DETROIT DIESEL

SERIES 60[®] Service Information

NUMBER: 14-60-00 Rev. **S.M. REF.:** 8.2 **ENGINE:** 60 **DATE:** August 2000

SUBJECT: IMPROVED VENT LINE ON 50DN ALTERNATOR

Figure 1 Vent Line Installed in 50DN Alternator

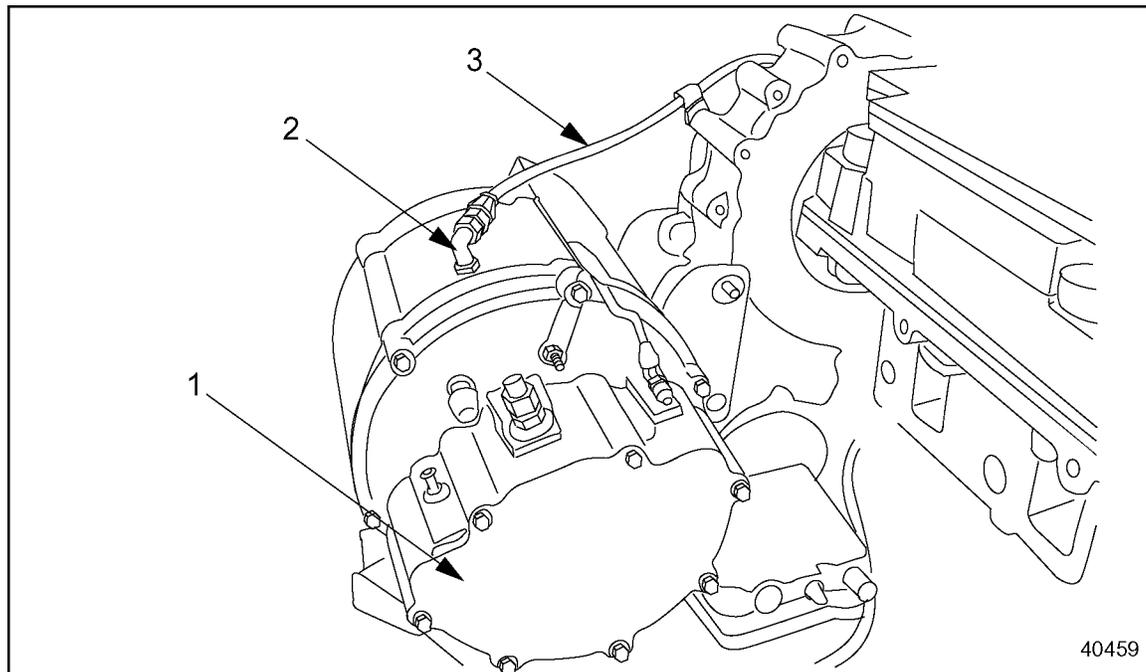
A larger diameter vent line has been released to provide improved venting for the oil-cooled 50DN alternator. The improved venting system uses a No. 6 steel-braided hose in place of the former No. 4 hose. See Figure 1.

The larger I.D. of the hose provides improved venting and helps eliminate the potential for vent line plugging. This improvement helps avoid high oil levels in the alternator, which can lead to insufficient cooling of alternator components. The improved line can help extend alternator life.

Figure 2 Vent Line Installed in Auto Tensioner Mounting Plate

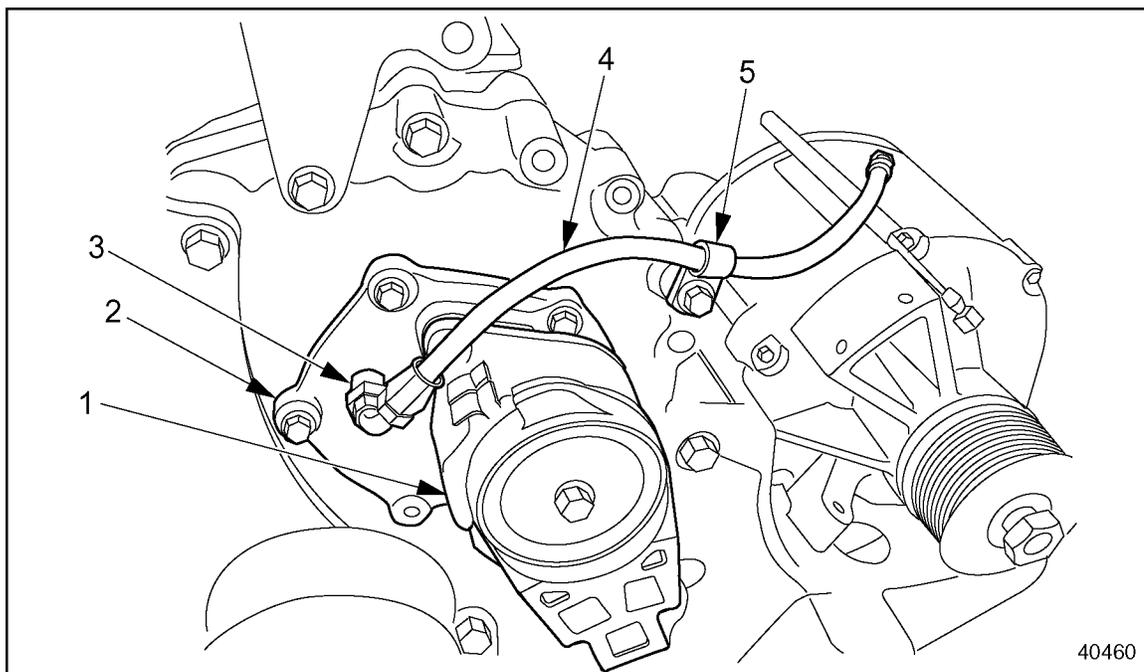
To conform with this change, a 90 degree, 3/8 in flared elbow is now installed in the 1/4 in. NPTF alternator vent hole. In addition, the engine vent line attachment location has been changed from the back of the gear case to a tapped hole in the drive belt auto-tensioner mounting plate. See Figure 2.

Figure 3 Location of Drilled and Tapped Vent Line Hole in Auto Tensioner Mounting Plate

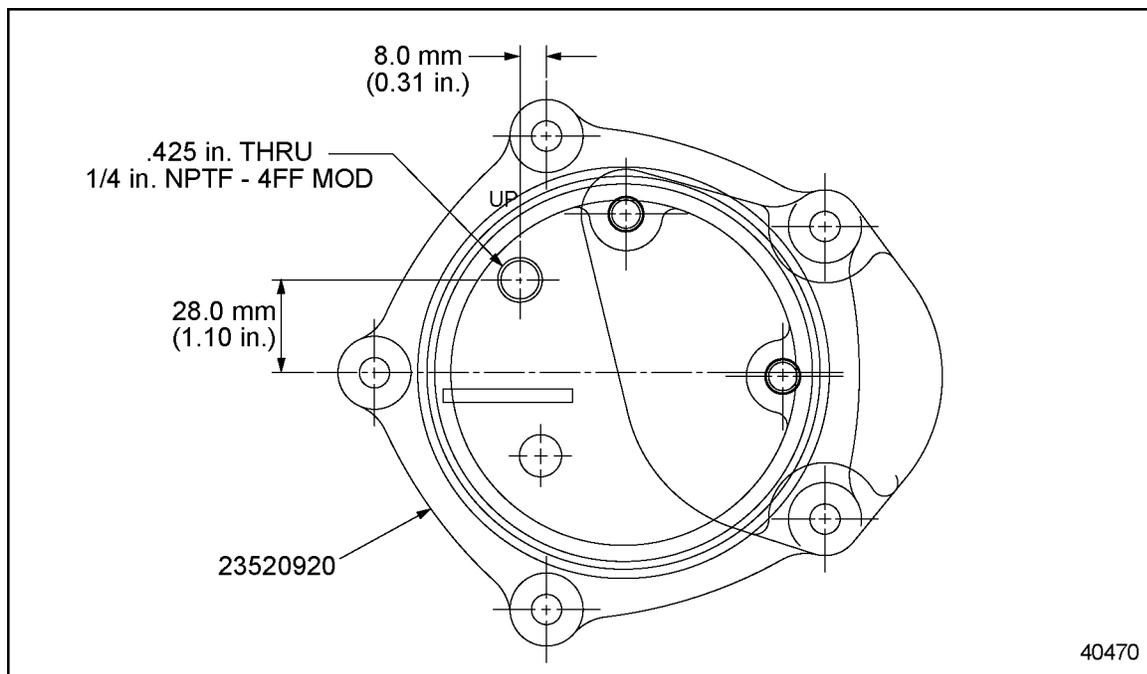
1. With the engine at ambient temperature and cool to the touch, remove and discard the former alternator vent line. Plug the vent line hole at the back of the gear case with a 1/4 in. NPTF square socket head pipe plug.
2. Remove the former vent fitting from the top of the alternator case.
3. Install the 3/8 in. flared to 1/4 in. NPTF, 90 degree elbow into the top of the alternator case.
4. Refer to section 8.2.2 of the *Series 60 Service Manual* and remove the alternator drive belt.
5. Remove the drive belt auto tensioner assembly from the mounting plate on the gear case cover.
6. Remove the mounting plate from the gear case cover.
7. Drill a .425 in. diameter hole on the left side of the mounting plate and thread with a 1/4 in. NPTF - 4FF tap. See Figure 3 for hole location.

Figure 4 Gear Case Cover Mounting Bolt Locations

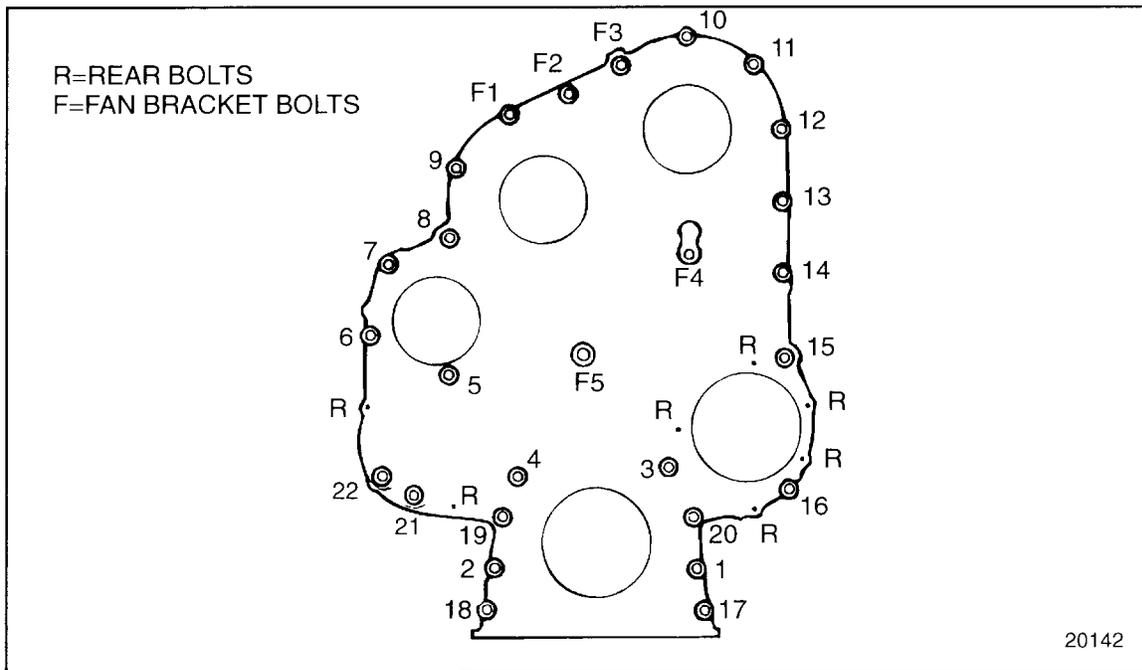
12. To prevent sags and low points, secure the vent line with the hose clip. Remove the gear case cover mounting bolt on the right side of the lifter bracket (bolt No. 12 – see Figure 4). Attach the hose clip to the bolt, reinstall, and torque the bolt to 58 –73 N·m (43 – 54 lb·ft).

12. To prevent sags and low points, secure the vent line with the hose clip. Remove the gear case cover mounting bolt on the right side of the lifter bracket (bolt No. 12 – see Figure 4). Attach the hose clip to the bolt, reinstall, and torque the bolt to 58 –73 N·m (43 – 54 lb·ft).
13. Refer to section 8.2.3 of the service manual and install the alternator drive belt.

Figure 5 Drilled and Tapped Vent Line Hole in Front Camshaft Cover

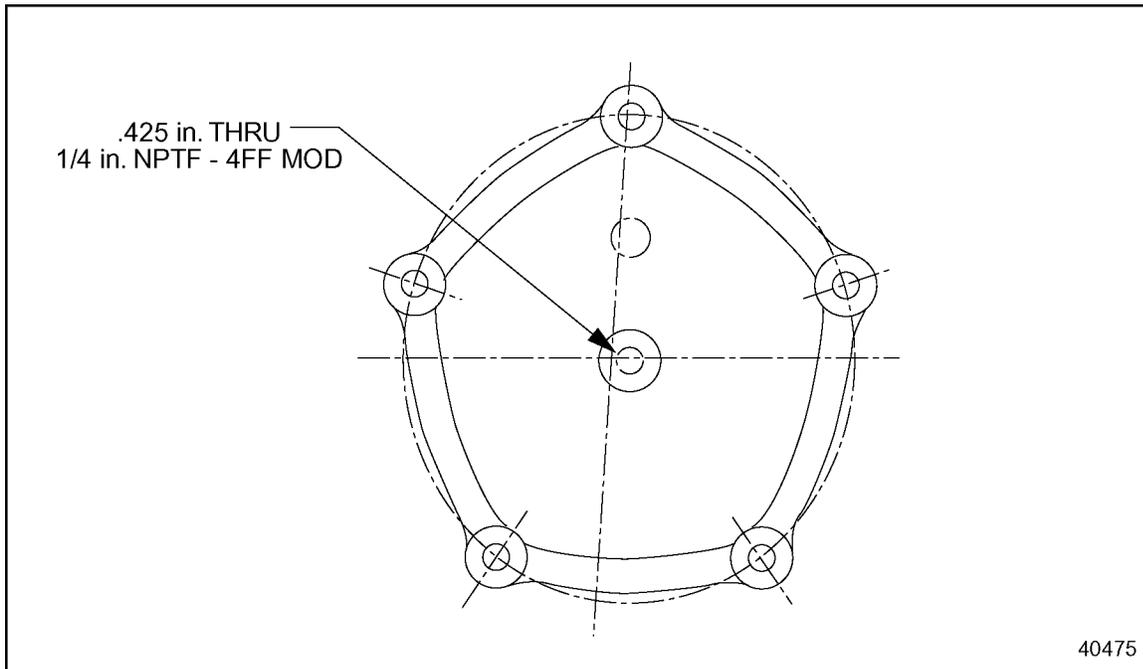
7. The center hole in the cover has a 1/8 in. NPTF thread which must be enlarged. Using a .425 in. drill bit, carefully drill out the tapped hole. Thread the hole with a 1/4 in. NPTF - 4FF tap. See Figure 5.
